Application Reference: EPR/SP3429LN/A001

Facility: Virtus Saunderton Data Centre, Haw Lane, Saunderton, HP14 4JD

I write in response to your request for additional information received via email on 15th June 2026, for Virtus' proposed Saunderton data centre Environmental Permit Application.

Requested Information	Responses and Supporting Documentation
Additional payment of £808.60 for the required Habitats Assessment	The payment of £808.60 was made on 19/06/2026 using the payment link provided and payment reference PSCAPPINSTVIRTU002 .

Figure AQ1: Aston Rowant SAC Modelled Receptor Location

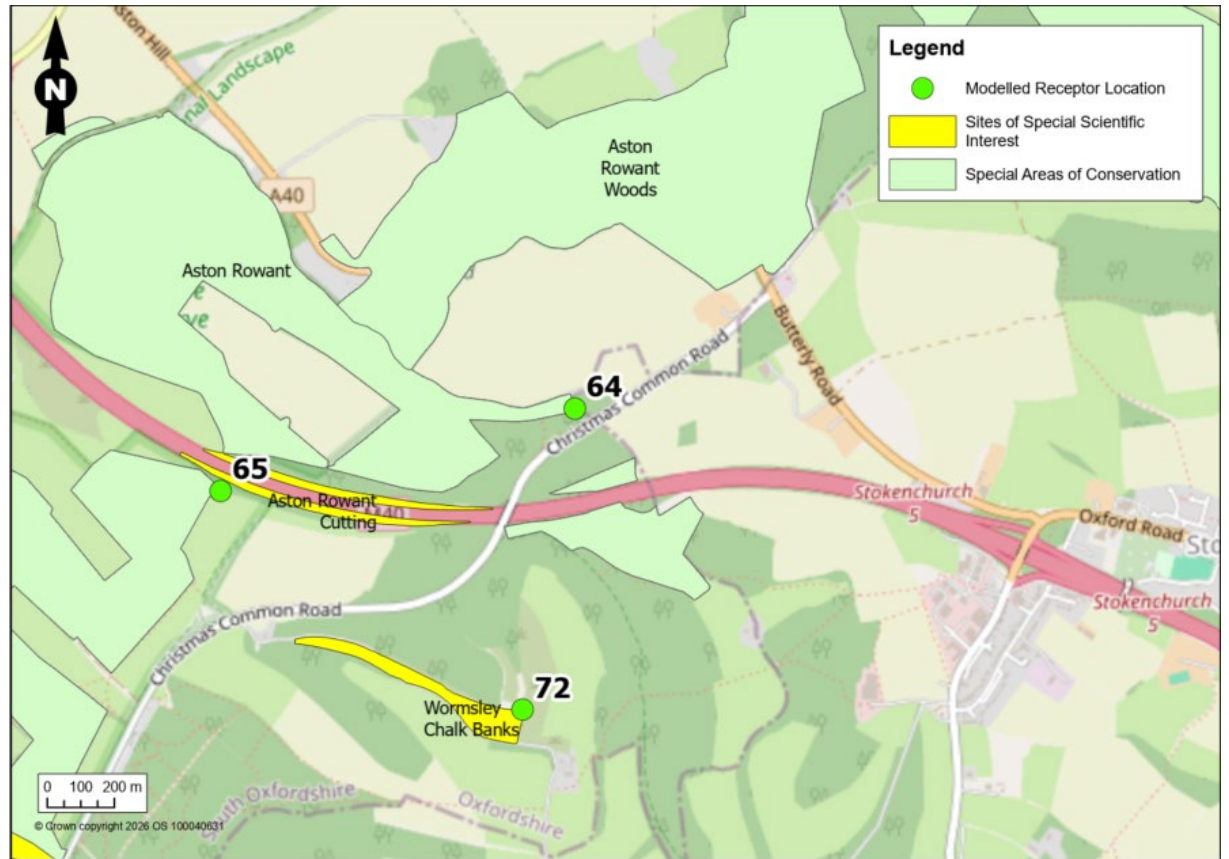
PM10: - 0.1 g/kWh - 5.84 mg/Nm³ 16M55G0D3/5 NOx: - 6.69 g/kWh - 1666.5 mg/Nm³ PM10: - 0.12 g/kWh - N/A mg/Nm³
The missing habitat sites within the minimum screening distance	
I. Aston Rowant (SAC)	This receptor has been included within the assessment at the modelled receptor point (473959, 196743) which has been labelled as Aston Rowant Cutting SSSI (ID 64). This receptor is located at Aston Rowant SAC/SSSI which has overlapping designation with Aston Rowant Cutting SSSI. The position of this modelled receptor is shown in Figure AQ1 below.

Figure AQ3: Small Dean Farm Bank and Gunner's Hill (LWS) Modelled Receptor Locations

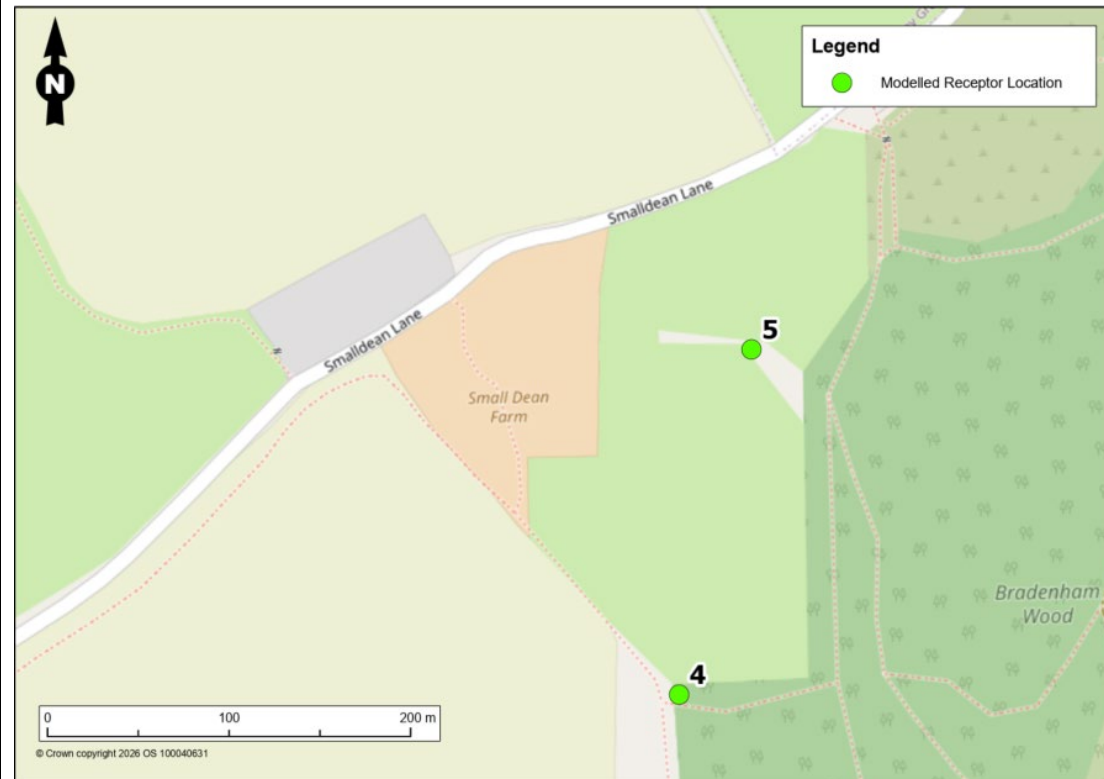
IV. Small Dean Farm Bank and Gunner's Hill (LWS)

This receptor has been included within the assessment at the modelled receptor points **ID4** (482205, 198658) and **ID5** (482245, 198848), which have been labelled as Chiltern Beechwoods SAC. This receptor has therefore been assessed against the more stringent thresholds applied to Ramsar, European and national designated sites. The position of this modelled receptor is shown in Figure AQ3 below.

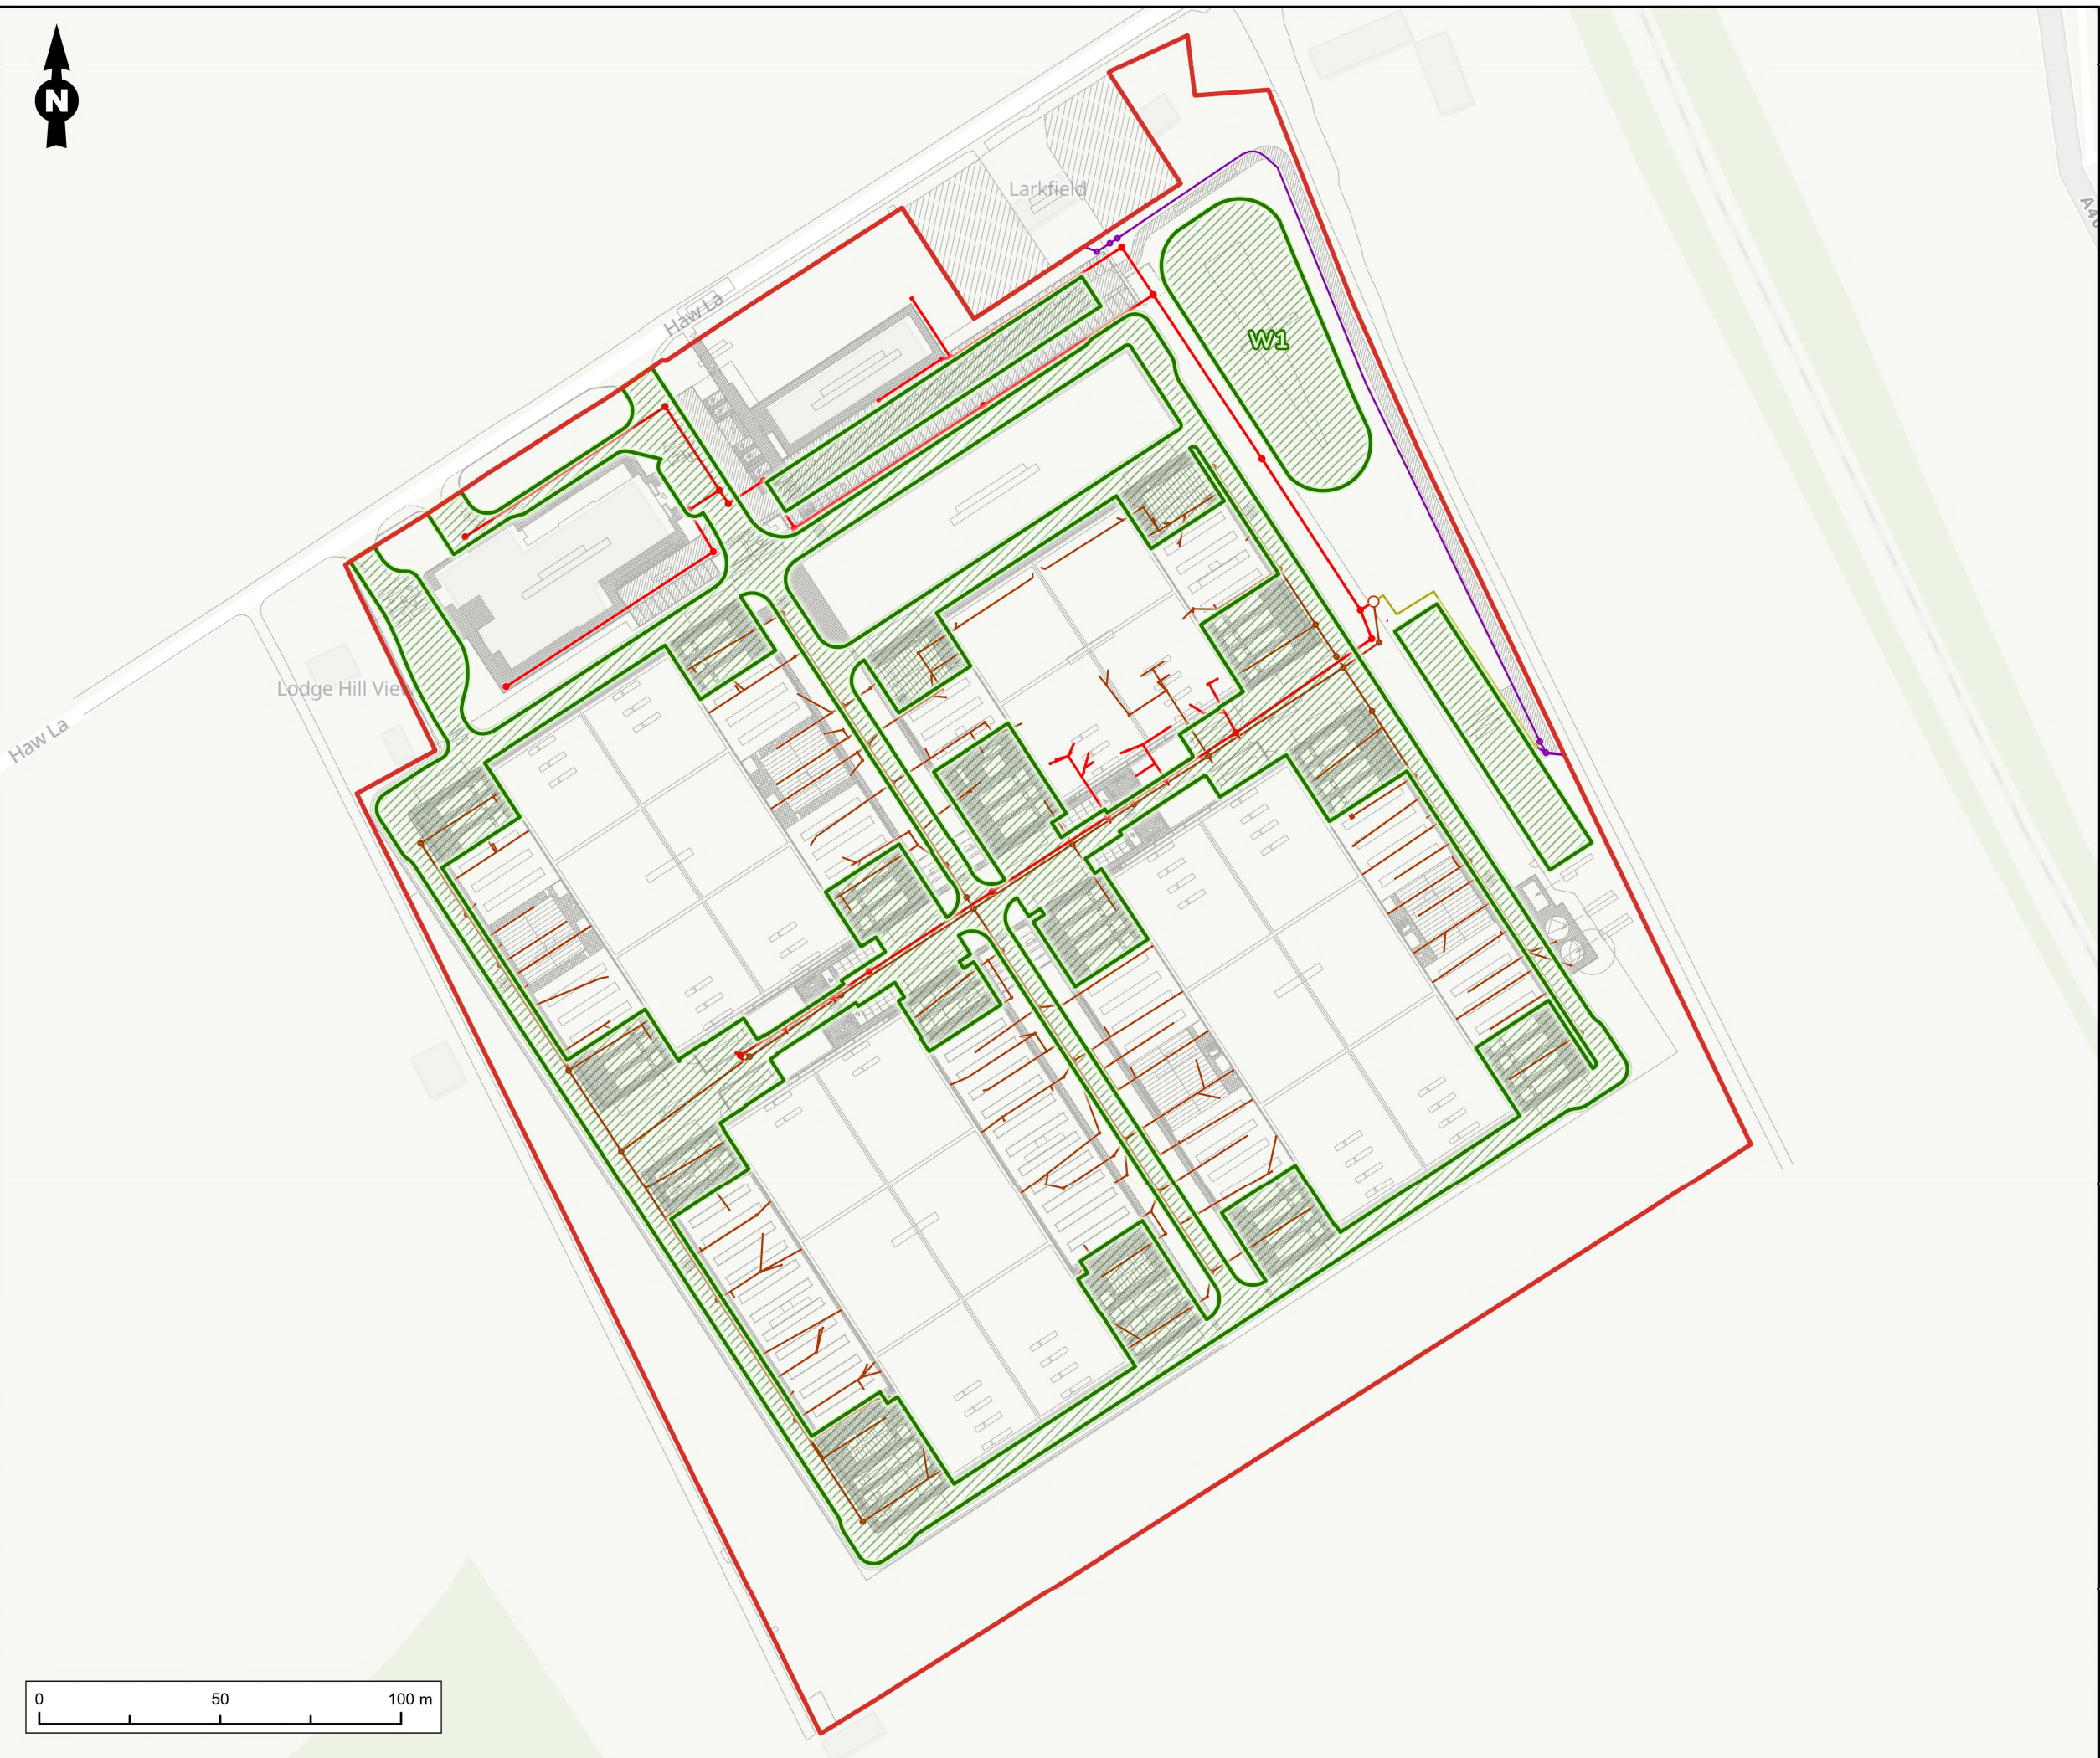
2. Site Plans	
- The seven missing emissions to air points	Please see attached Figure 1 – Installation Boundary with Emissions to Air Locations , which includes all 57 emissions to air points.
